**GENERAL ARRANGEMENT & DATA SHEET FOR BOOSTER FAN CUSTOMER, NPC LIMITED. GENERAL ARRANGEMENT & DATA SHEET FOR BOOSTER FAN STAGE-I(3X200MM) & STAGE-II(3X200MM)**

Rev No	Date	Details of Revision	
00	21/05/2020	First Submission	
01	26/06/2020	<b>NTPC Comments:</b>	<b>BHEL Replies:</b>
		Furnish Painting scheme for complete Limestone and Gypsum Handling Plant.	Limestone and Gypsum Handling Plants are not in BHEL-Ranipet scope of supply. Painting requirements for these will be submitted by BHEL-ISG during detailed designing.
		BHEL to mention specification clause in every sl no. wherever it is not mentioned.	Mentioned wherever not available.
		Mention the IS clause for handrails as per specification wherever necessary in this document.	IS:4736, referred in NTPC Technical Specification, has been mentioned for hot dip galvanizing of handrails.
		Sl No: 5 of Fans: a) Delete MIO everywhere in this document Titanium dioxide is only option as per spec. b) Please mention With glossy finish as mentioned in spec.	a) MIO deleted wherever Titanium dioxide (TiO <sub>2</sub> ) is specified in the technical specification. b) Glossy finish included.

**PROJECT**  
**RAMAGUNDAM I & II (3X200MW+3X500M

View-XX

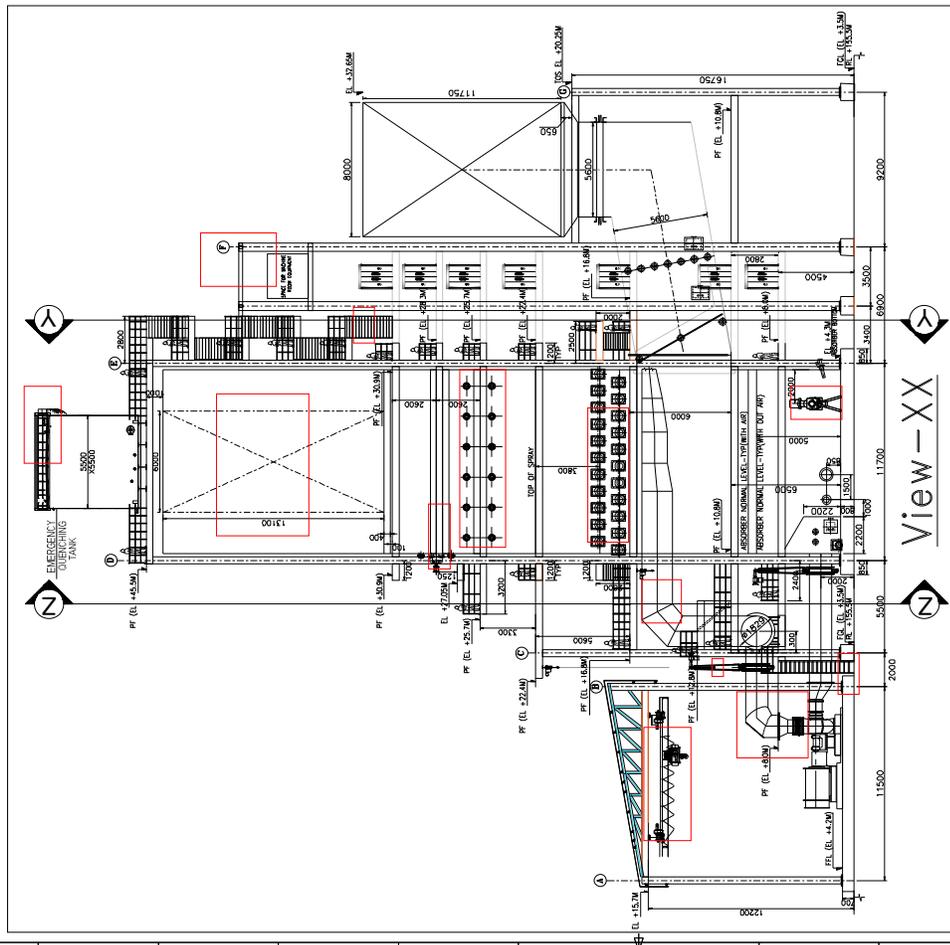
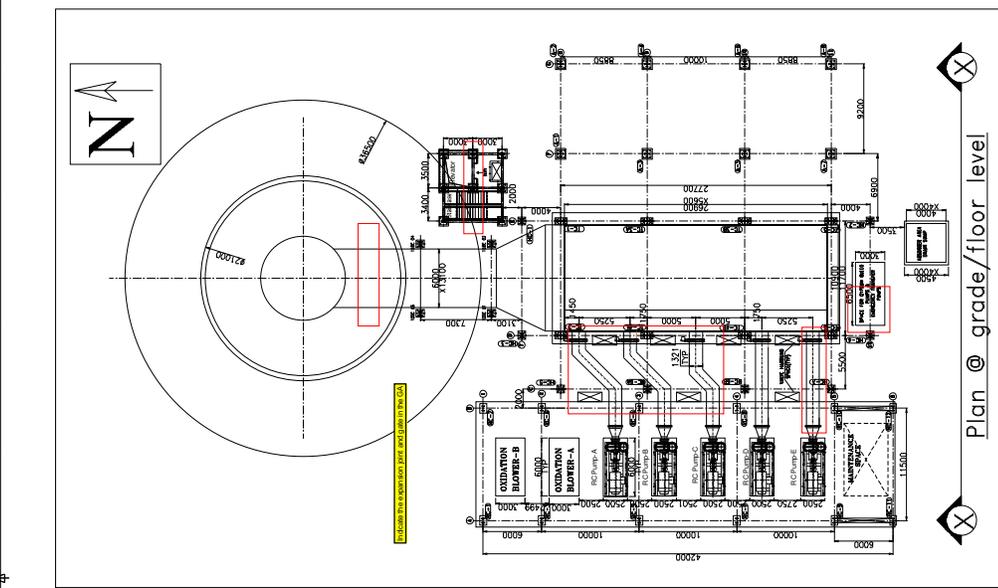
Comments related to the drawing is shown in yellow.
